April 29, 1907.

Mr. L. L. Stephens,

In reference to repairing the washout at the outlet of Ditch No. 42: While the water in Run River is at its present stage, it will, perhaps, be difficult to replace the tile which have washed out. If so, you should protect the other tile from washing out at present, and replace the remaining ones ~~when the flush boards~~ when the flush boards are removed from the draw and the water goes down. By filling in a mixture of coarse concrete, say, one part of Portland cement to five parts of sand, about the tile and extending the mixture two and a half feet either side of the tile and one and a half feet above and below, I think you can keep the tile from washing out further. Then, when the water goes down, replace the other tile and the box. At the end of the box, place a concrete retaining wall. This should be of concrete made of one part portland cement, ^{three parts sand} and five parts gravel. It should reach from one and a half feet below the bottom of the tile to one and a half feet above the same, and should be five feet wide. The thickness at the bottom should be ~~one and a half feet~~ ^{one foot}; at the top four inches. Four half inch ir

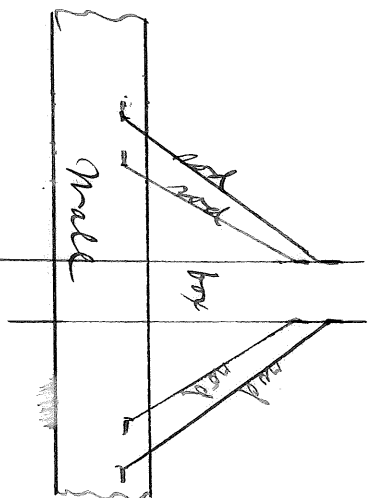
The box shall extend through the concrete wall about two feet.
